Research Reactor Center

REFERENCE: Docket 50-186
University of Missouri Research Reactor
License R-103

SUBJECT: Response to NRC's Request for Additional Information dated
December 12, 1996

Figure 6.0

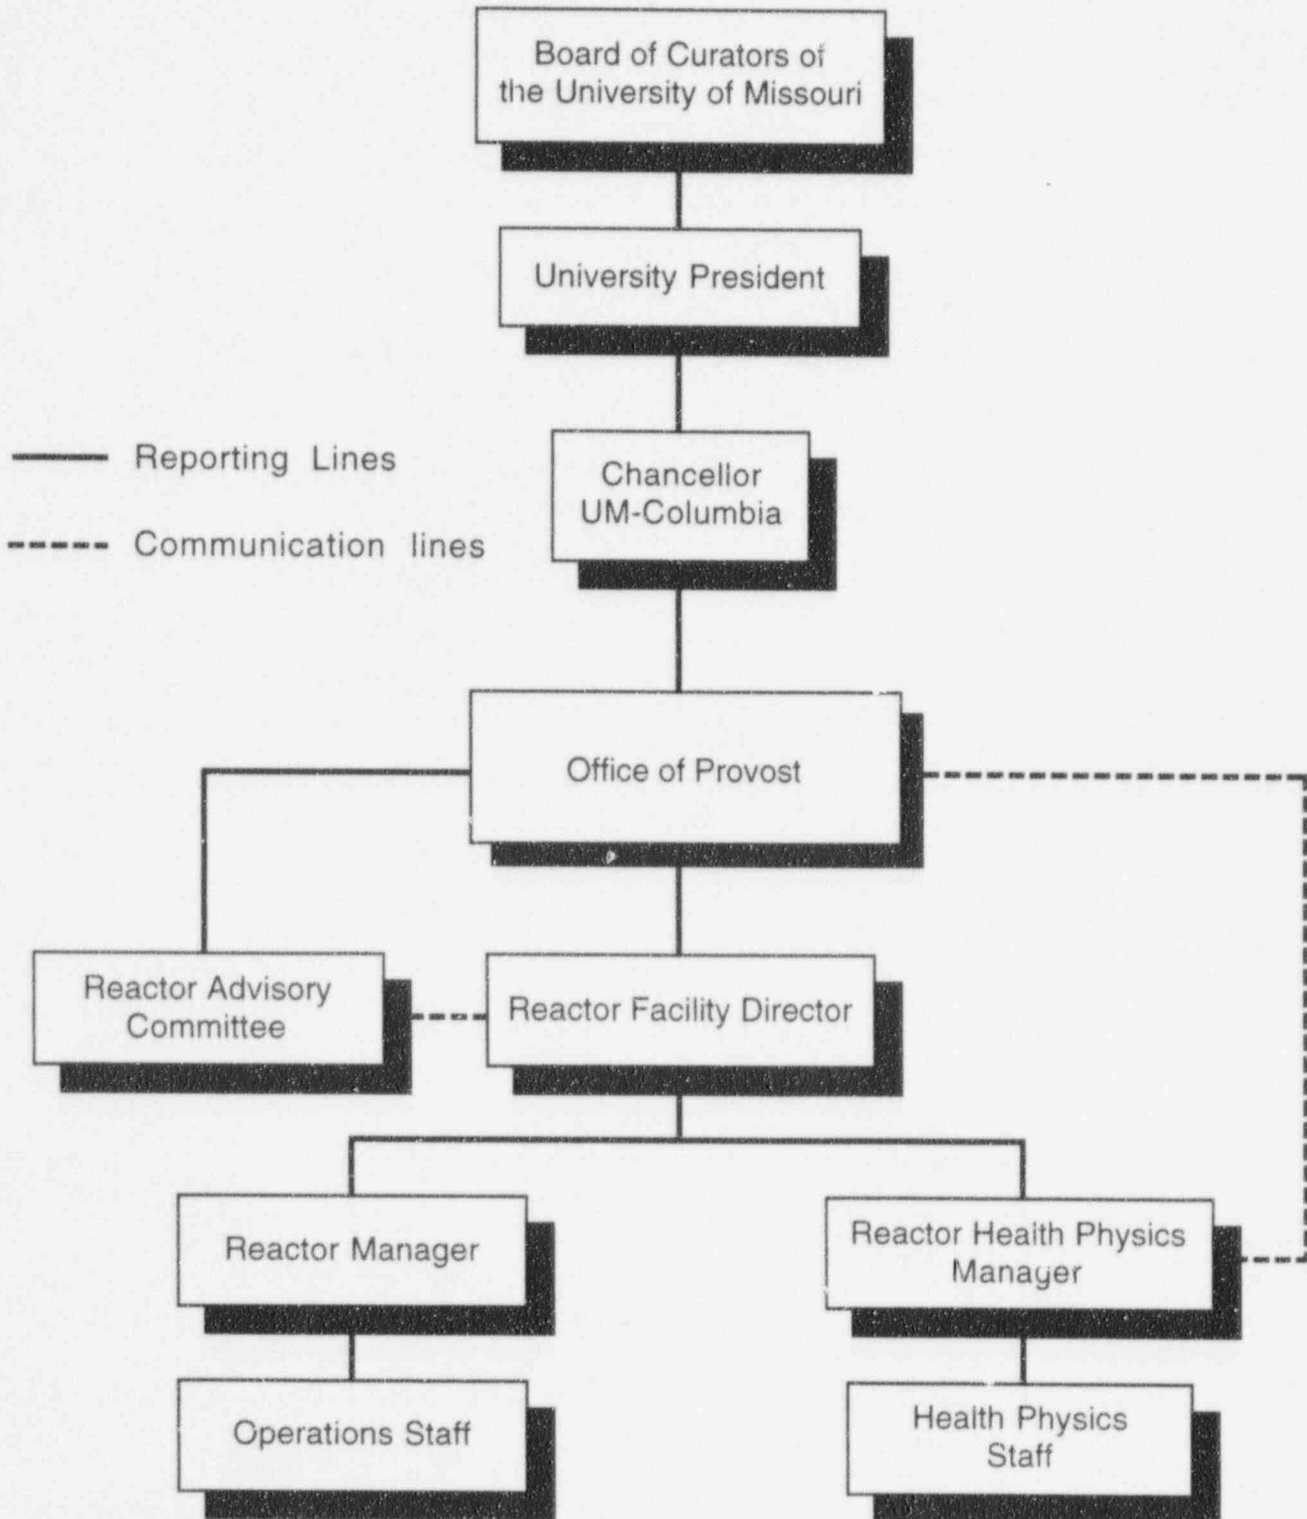
2. *Please add a legend to Figure 6.0 that defines the meaning of solid and dotted lines between organizational units.*

- 4. You have made several changes to Figure 6.0 that are not discussed in the application amendment. The title "Board of Curators of the University of Missouri" is changed to "Board of Curators for the University of Missouri," the title "Reactor Facility Director" is change to "Reactor Center Director," and the title of "Vice President for Administrative Affairs" is removed from the organizational chart. Please provide a discussion of the justification for these change if you desire to make them.*

A legend defining the meaning of the solid and dotted lines between the

organizational units has been added to Figure 6.0 (enclosed). This legend follows the guidance of ANSI/ANS-15.1, Section 6, Administrative Controls.

A revised Figure 6.0 is enclosed that retains the previous titles of the Board of Curators and the Facility Director. We do not wish to make changes to these titles at this time.

The title "Vice President for Administrative Affairs" should be removed from the Organization Chart. This position in our current Technical Specifications is not in the direct line of license responsibility for the reactor. This title was previously included on the request for our current organizational structure for illustrative purposes only.
